RE: **SAJ-2004-12518-CHF (St John Marina) – The Summer’s End Group LLC**

**Comments on Information Provided by Applicant Pursuant to NMFS HCD and NMFS
PRD Information Requests**

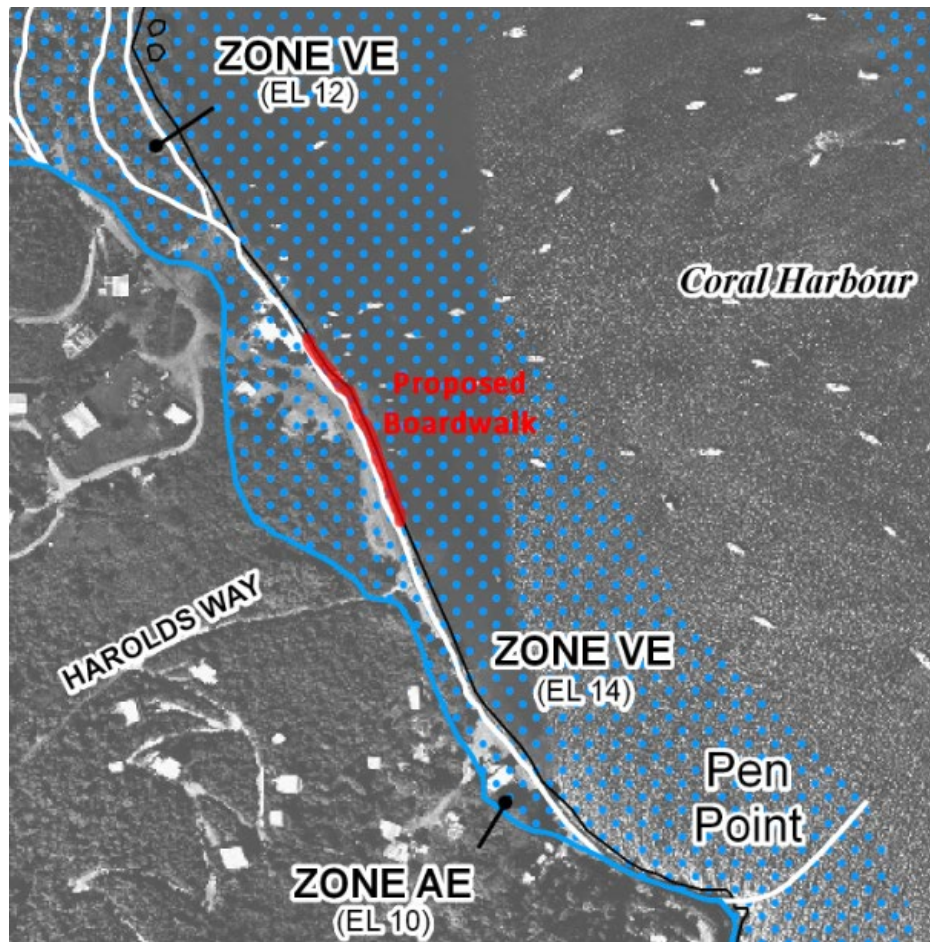
When Parcels 13-A and 13-B Carolina were sold to a third party and became unavailable for use in the marina project, Summers End was forced to revise the storm water management design. The drawings submitted in August 2017 (the most current design) has reduced the capacity of the storm water detention by at least 70% and eliminated most of the rechanneling of the drainage gut. This new design will be inadequate to contain runoff and remove sediments which will be deposited into Coral Harbor directly at the head of the marina. The new design does not even meet the requirements identified by the Applicant in their own 2014 EAR, as shown above.

The Applicant's table of "Proposed Mitigations" includes the descriptive comment "underground stormwater sediment settlement and detention of 3,294 gallons +/- provided on Parcel 10-41 Rem. Identified on civil plans as Underground Storm Storage." This must be an error. A capacity of 3,294 gallons (equivalent to 422 cubic feet) is less than 2% of the required capacity. The 2017 drawings indicated 9450 cubic feet of underground capacity, which is still a small fraction of the required capacity for the 1-Year storm event.

This is a major change in design, a major reduction in public and environmental benefits, and raises the potential that deposition of sediments within the marina footprint will necessitate dredging in the future.

It should be noted that the Applicant has not identified the major reduction in storm water management and sediment control as a change in their table of Proposed Works, and in fact this is labeled, incorrectly, as "No Change".

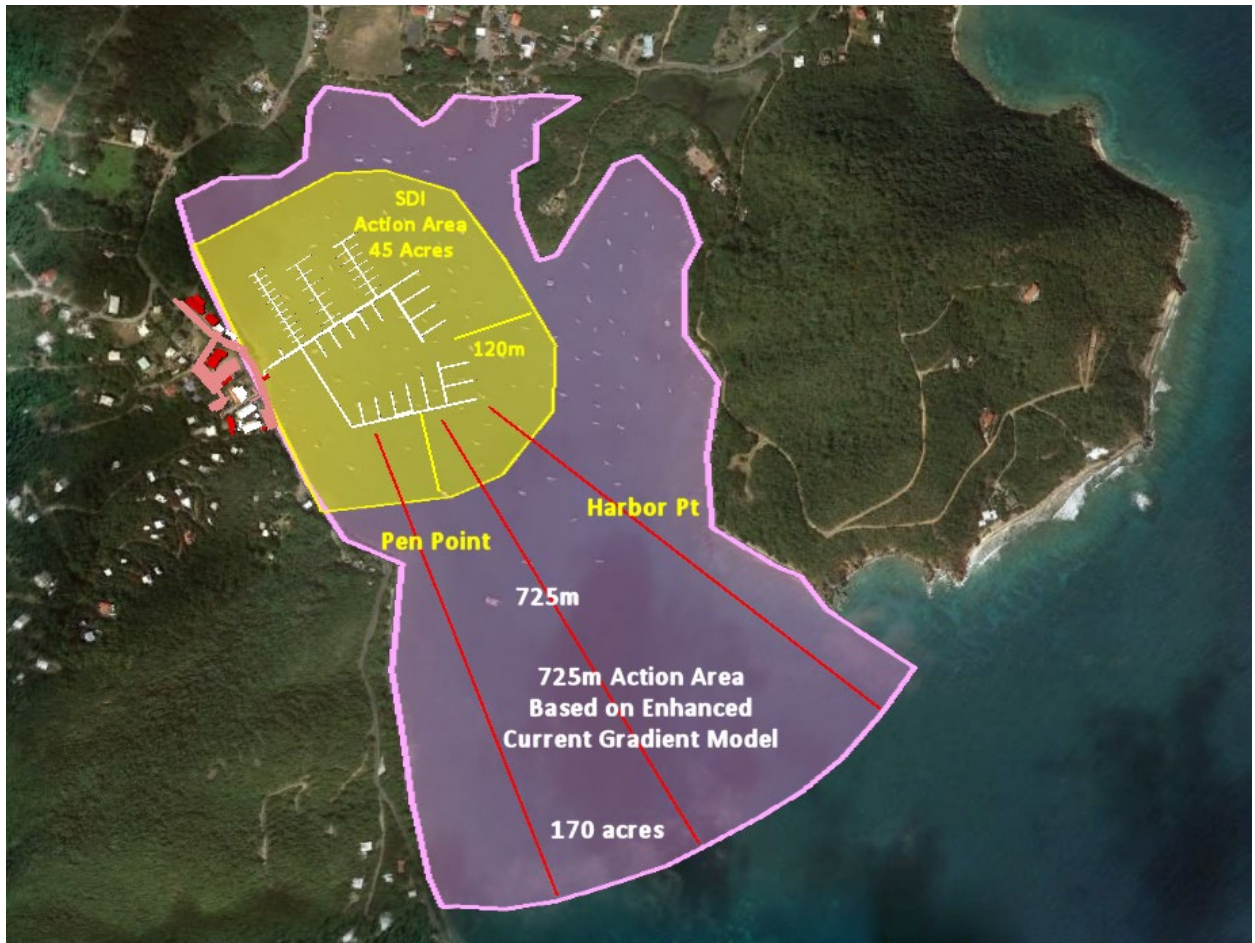
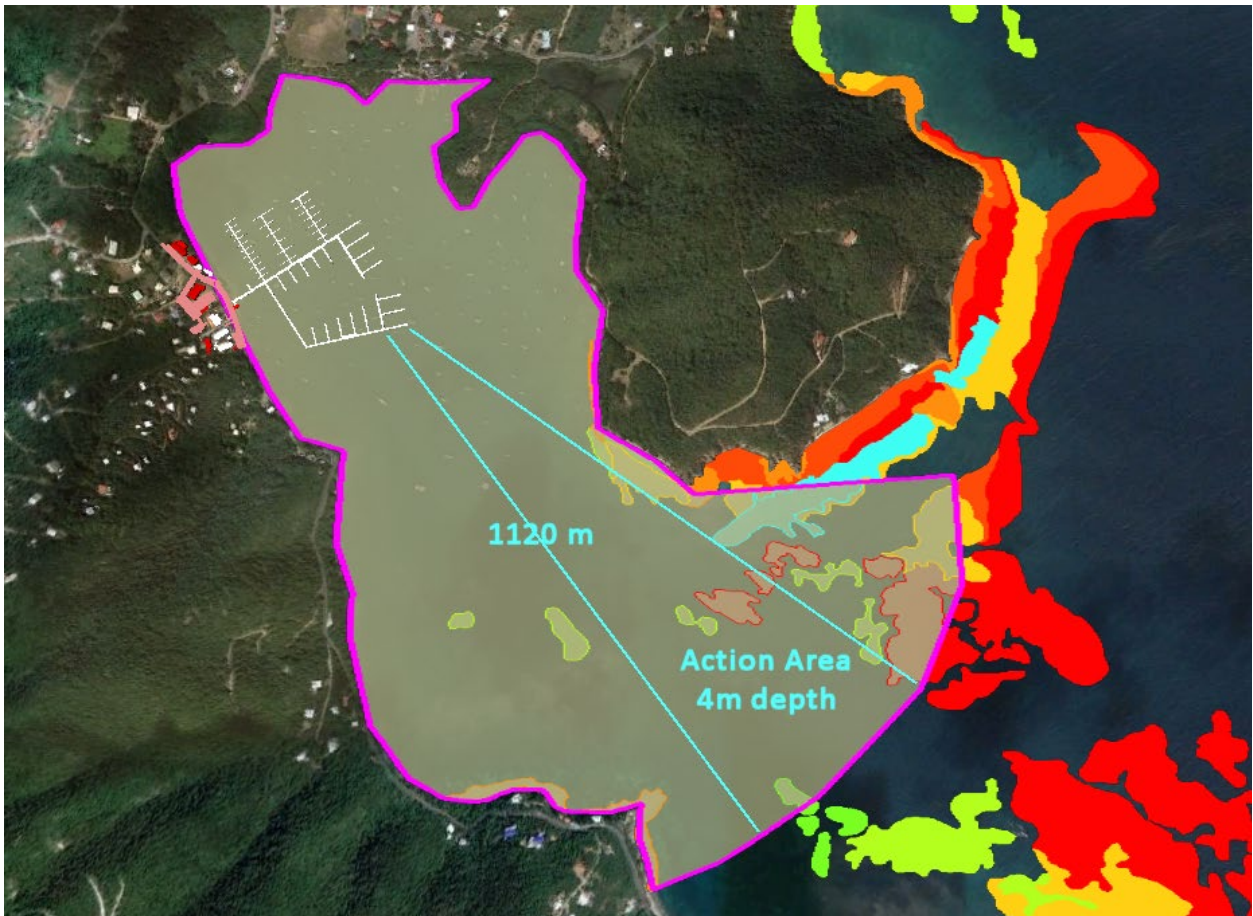
After analyzing the data provided by the Applicant, particularly their water circulation study, and incorporating the best available scientific information, as required by federal regulations, we concluded that the Action Area should extend 725 meters from the southernmost reach of the marina, and encompass an area of 170 acres. We also concluded that at least two identified sites for ESA-listed coral species at the entrance to Coral Harbor (Pen Point and Harbor Point) will be within the Action Area and will be impacted by resuspended sediments transported to these locations. We also concluded that there is a significant likelihood that circulation patterns modeled by the Applicant will be capable of transporting sediments into Hurricane Hole, within the Virgin Islands Coral Reef National Monument.

The diagram below, which is fully explained in our March 2020 report, illustrates the Applicant's proposed action area ("SDI Action Area 45 acres"), and the corrected action area based on an enhanced current gradient sediment transport model, and based on actual sediment composition sourced from recent scientific studies. It is apparent that the Applicant has grossly underestimated the area of impacts.

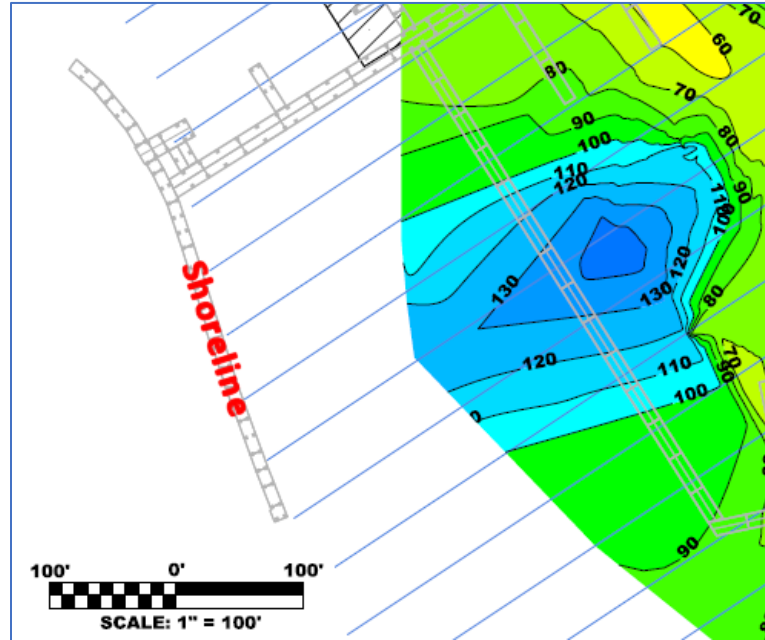
- SDI say they are hitting "apparent bedrock" at 40'-150'.
- We penetrated a max of 2 m (<7') with a similar system and same topside unit.
- The sediments in Coral Harbor are a mixture of siliciclastic and carbonate sands (primarily), with the later dominating in the proposed marina area. It is very difficult for the acoustic signal to penetrate through carbonate sands, which is likely why we only got ~2 m max. Therefore, I would say their claim of 40-150' penetration is highly suspect at best.

- The interpretation of "apparent bedrock" based on very few subbottom reflectors is an over interpretation, and therefore is suspect.
- Our cores in the same area encountered non-marine pre-Holocene material less than 1 m down core, which means >1m of sediment has accumulated since the area was flooded by the Holocene sea-level rise ~6,000 years ago. Therefore, it is highly unlikely that bedrock would lay 40-150' below the surface.

In addition to these expert comments, the presence of bedrock outcroppings on the surface in close proximity to the shoreline casts doubt on the extreme bedrock depths reported by SDI. For example, SDI reports a depth to bedrock of 120' at a distance of less than 100' from the shoreline which seems highly unlikely:

Given the extreme significance of the geophysical survey to the viability of the piling installation, we respectfully request that additional independent verification be performed. This could take the form of a test core or probe in a number of locations to validate depth to bedrock, or an independent analysis of the data collected by SDI. At the very least additional measurements should be taken in the areas not covered by the current report.
